## COMMITTEE REPORT

READING BOROUGH COUNCIL

Address: The Three Guineas Public House, Station Approach, Reading

**160525/LBC:** Internal alterations at basement, ground and first floors.

23635PL01 Issue 2 page 2 of 5: Signage Specifications for signs A-G [Sign B not approved]

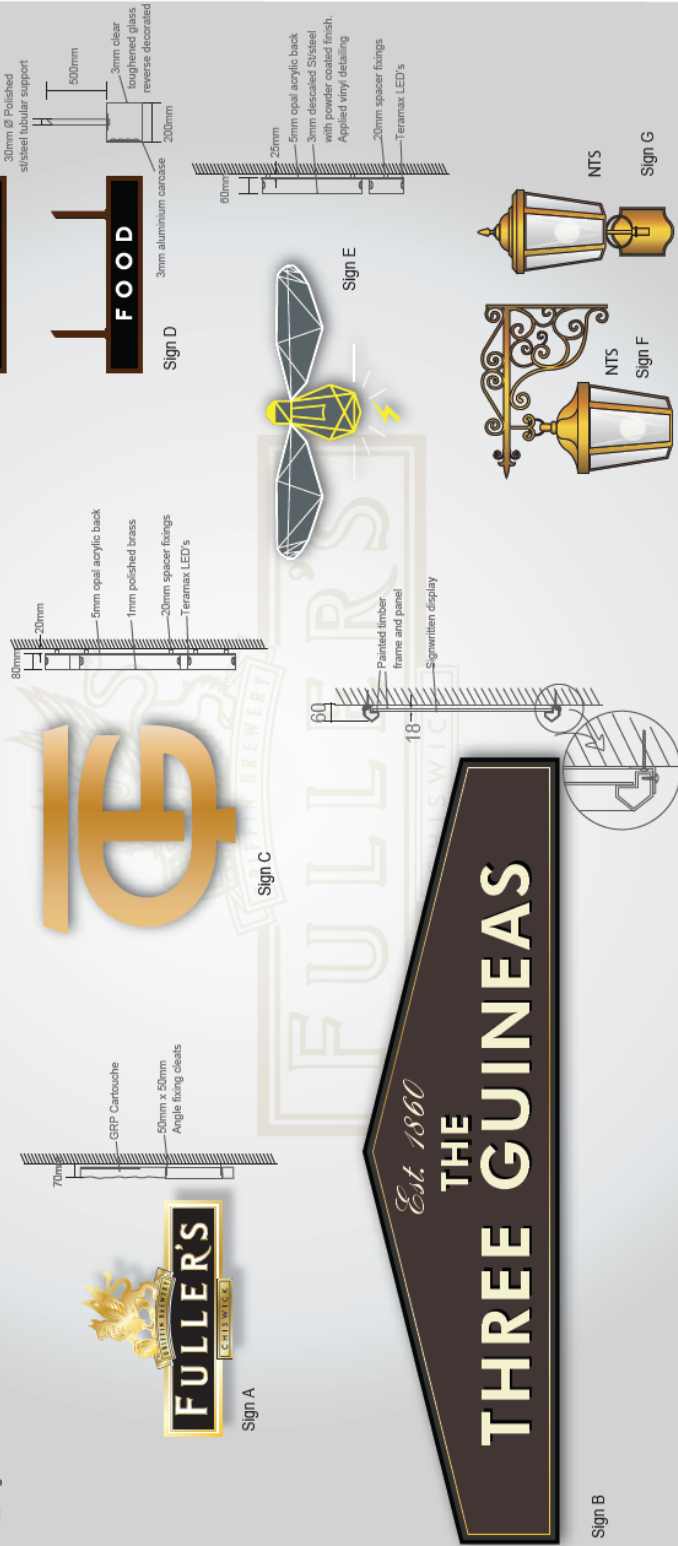
6.22 The application proposes a series of signs. The principal replacement sign was to have been a large panelled sign affixed to the parapet upstand on the roof of the building and both officers and amenity societies were concerned that this sign was too bulky. The applicant has now chosen a much more restrained solution, that of sign-painting the parapet upstand itself. This is considered to be a far more traditional solution and is welcomed. To confirm this, a condition is recommended.

1. Plans approved, including updated parapet painted sign (Sign B)
2. Standard advertisement conditions

Ground Floor Plan as Proposed  
 showing references to  
 Heritage Statement

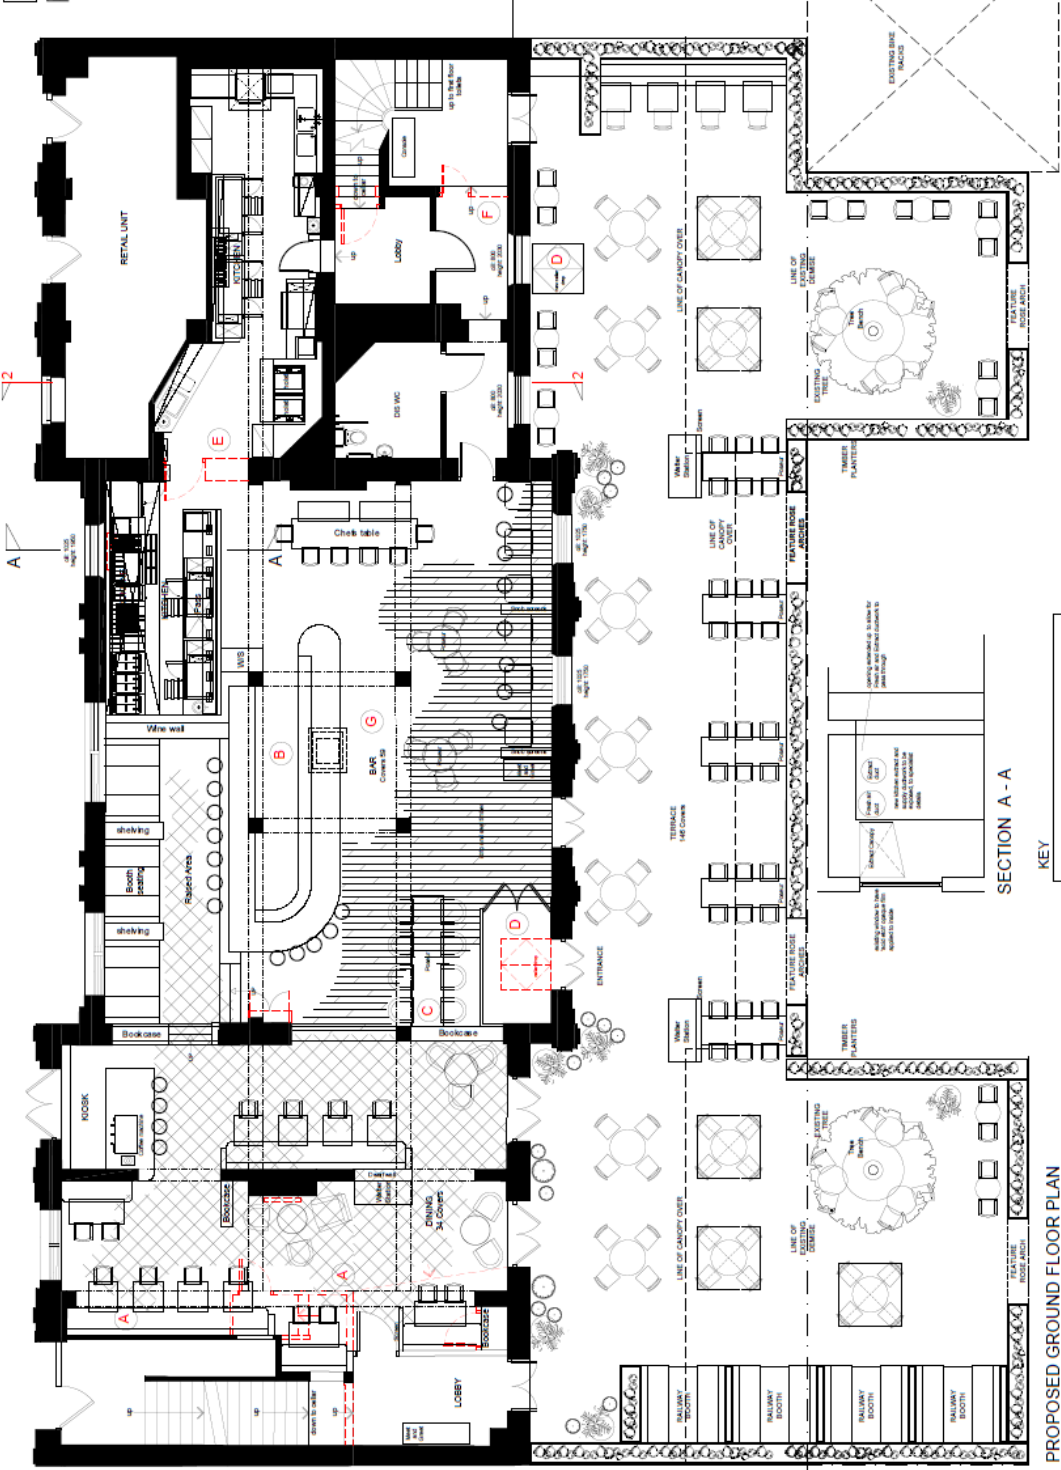
- 6.9 However, the extended kitchen area will require large holes to be introduced at high level for extract vents and the removal of a short section of original wall. Both are considered to be suitable adaptations. However, the 'display' cooking area currently shows a large boxed ventilation overhead system and this would be deep, coming below the top of the tall windows (which front the platform). This would be potentially bulky and intrusive. On the advice of officers and the Council's Conservation Consultant, the applicant is exploring more open, exposing venting arrangements. Current plans show that this bulky area has been reduced towards the interior of the building. However, the extract hoods themselves are sited towards the edge of the building and would be seen below the top of the windows from outside, but to address this, the applicant proposes that the windows be obscurely etched to minimise the impact of this. Subject to details of these arrangements being secured by

- 6.10 Another area where additional information was requested was the method of forming openings in the ceiling to form the new ceiling hoists (dumb waiters) for the food coming from the first floor. These details have now been supplied and subject to confirmation from the Conservation Consultant, are considered to be acceptable.
- 6.11 Whilst officers have raised the question of whether the ground floor changes (which feature a heavy emphasis on food-related equipment and furniture) would amount to its use as a restaurant, the applicant has advised that this will remain as a pub with a pub food offer. In any event, any alteration to this would be separately covered under the licensing system.

condition and favourable comments from the Conservation Consultant, this is considered to be a satisfactory solution.

Basement Plan as Proposed  
Including References to  
Heritage Statement

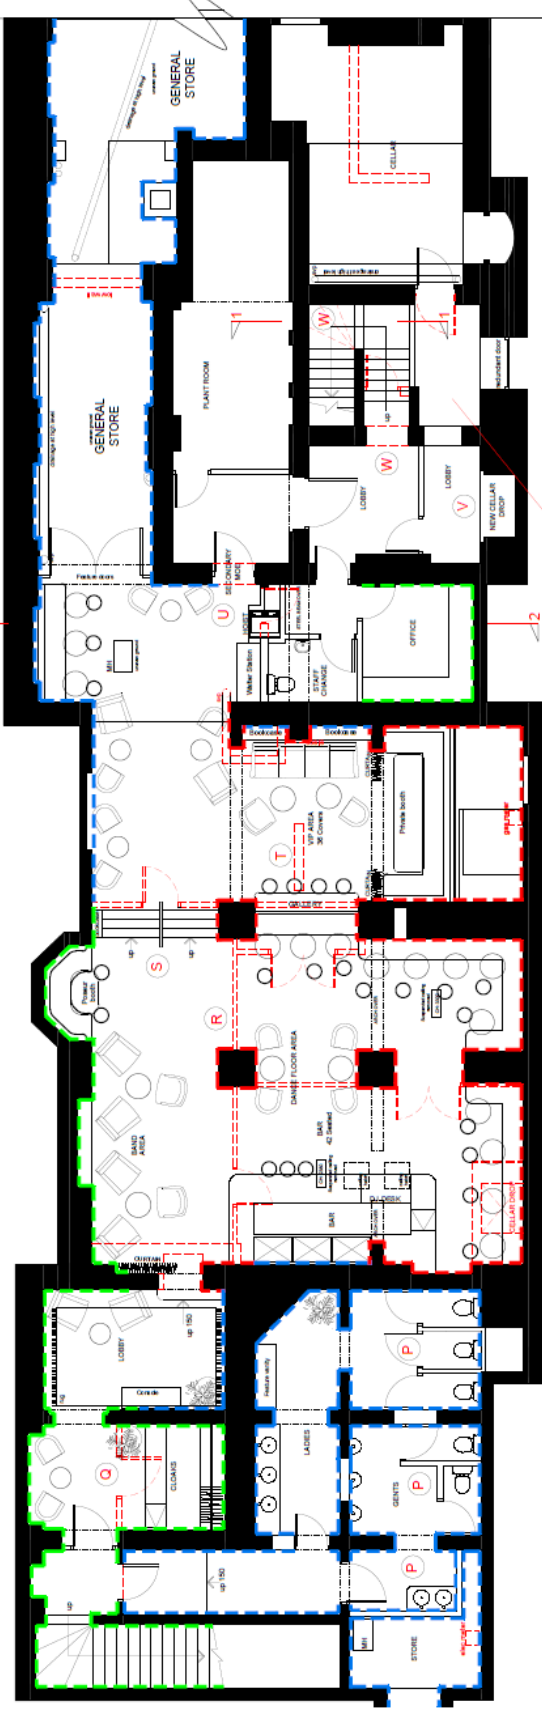
- 6.14 The cellar is currently damp, having never been designed as part of the habitable part of the building and the application proposes a number of measures to deal with this. For the walls, there are three approaches. Where a modern hard 'Sika' render has already been applied (towards the western end of the cellar) this will remain, as removing it may inadvertently harm the building. Where there the tall, impressive brick arches and vaults are to be exposed, the bricks and mortar will be cleaned and left untreated with adequate ventilation. This will be of benefit to the fabric of the building and celebrate the character of these areas. The third approach (generally for use in the service areas, stores and toilets) is for a batten and dry-lining system, in order to insulate the walls, but will include a self-

- 6.15 At the eastern end of the building, there are some intact utilitarian features, such as panelled doors, flagstone floors and the stone stairs. The stairs need to be adjusted for safe fire escape and will remain in situ, but with new timber risers and treads sensitively attached. An enlarged headroom is required, but the room required for this means cutting into a concrete ceiling (the entire ground floor appears to be concrete) so no harm is caused to the historic fabric. An original cupboard is to be knocked through at the foot of the stairs, but an in-built arch will be retained over. In this area, the original barrel-drop (currently in situ, but disused) will be re-opened. The stairs at the western end are a straight flight of original stone steps and will not be altered. There is a change in levels in the middle part of the basement where new timber stairs will be required. Floors would be screeded and also have a draining system to carry moisture away.

- 6.17 Whilst there is no in principle concern for the use of this area, officers have raised concerns with the applicant that on plan, the layout looks to be producing a separate planning unit, as a bar or possibly a nightclub. The plans show a separate greeting area in the new ground floor lobby and the cellar area having its own manned cloakrooms, toilets, bar, dancefloor, band area, seating booths and VIP area. However, this largely will depend on how this area operates and if this area is subsequently operated as a separate bar/club, the Local Planning Authority will need to decide if this is acceptable or if a retrospective planning application is required. An informative is recommended to remind the applicant of this.
